Delegated or Committee Planning Application Report and Report of handling as required by Schedule 2 of the Town and Country Planning (Development Management Procedure) (Scotland) Regulations 2013 relative to applications for Planning Permission or Planning Permission in Principle

Reference No: 15/03176/PP

Applicant: Scottish Water

Proposal: Installation of 2 Service Reservoirs and Associated Works

PLANS SHOWING ORIGINAL AND PROPOSED ACCESS ARRANGEMENTS TO SERVE TELCOMMUNICATION SITE WITHIN APPLICATION SITE

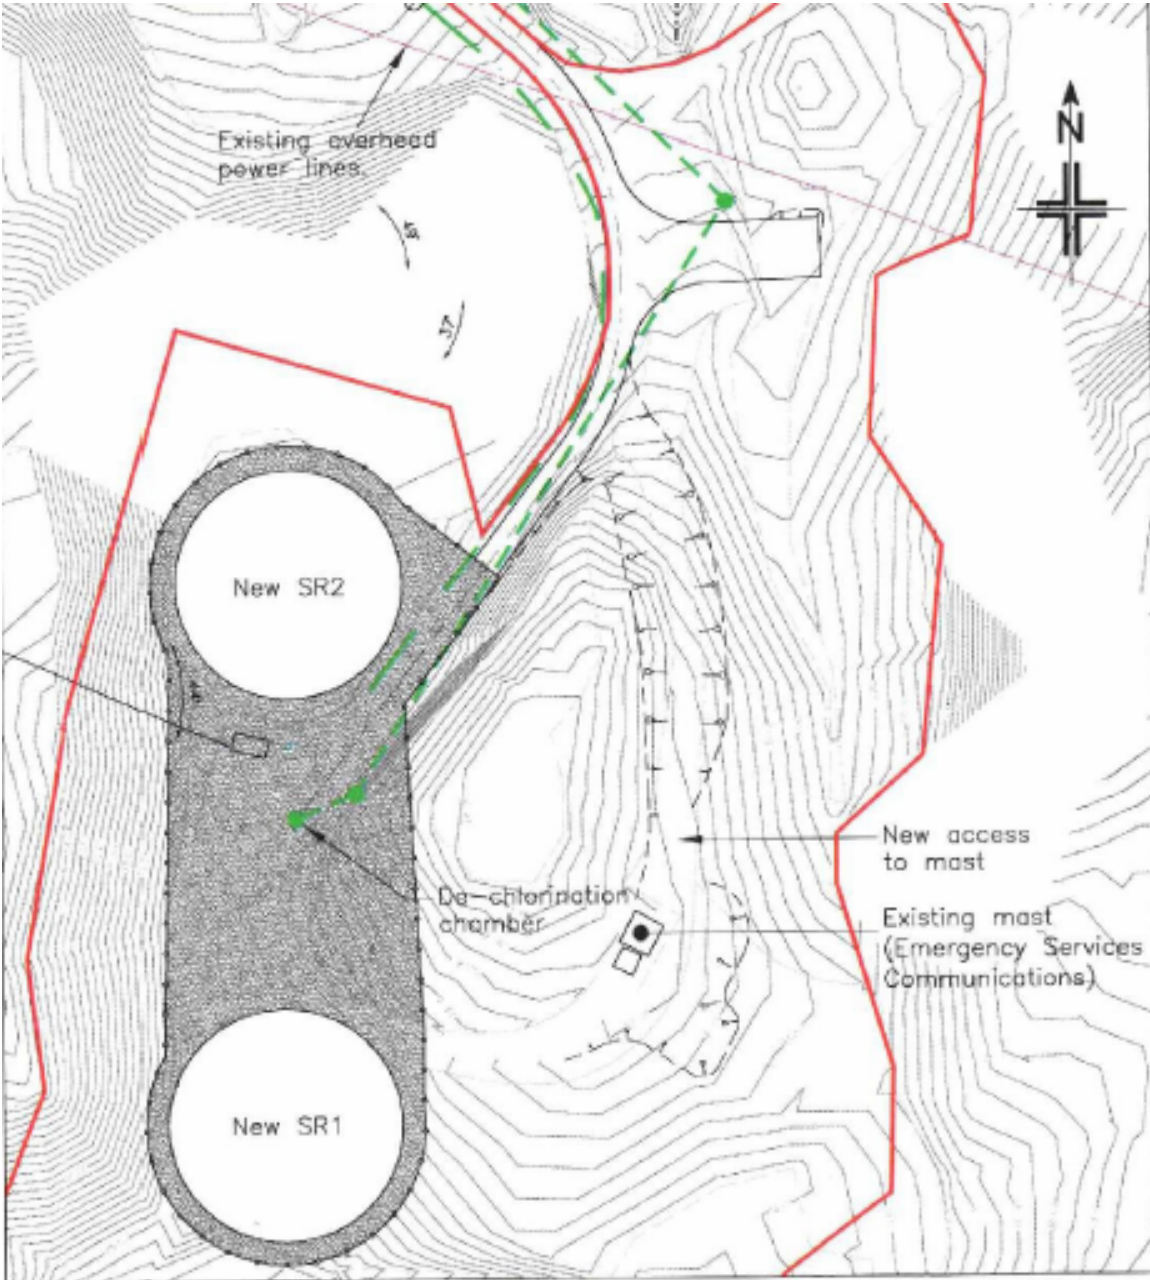
The original proposal included a new track to maintain access to the adjacent telecommunications site which falls within the boundary of the application site. Concerns were raised by the Roads Authority regarding the proximity of this track to the route of the proposed Oban Development Road. As a result of these concerns discussions took place with Scottish Water which has resulted in the access track being relocated to the west of the originally proposed position, but still within the confines of the application site, which has satisfied the Roads Authority who confirmed that the revised location will have no adverse impact on the route of the proposed Oban Development Road.

During the processing of the application concerns were raised by the Area Roads Authority regarding the proximity of the proposed access track to serve the adjacent telecommunications mast to the route of the proposed Oban Development Road. As a result of these concerns, discussions took place with the applicant which has resulted in the proposed access track to serve the mast being relocated further to the west which has satisfied the Roads Authority who confirmed that the revised location will have no adverse impact on the proposed Oban Development Road. The relocated access track falls within the confines of the existing application site representing a non-material change to the proposal.

Plan 1 – Originally Proposed Access Route

Plan 2 – Current Proposed Access Route
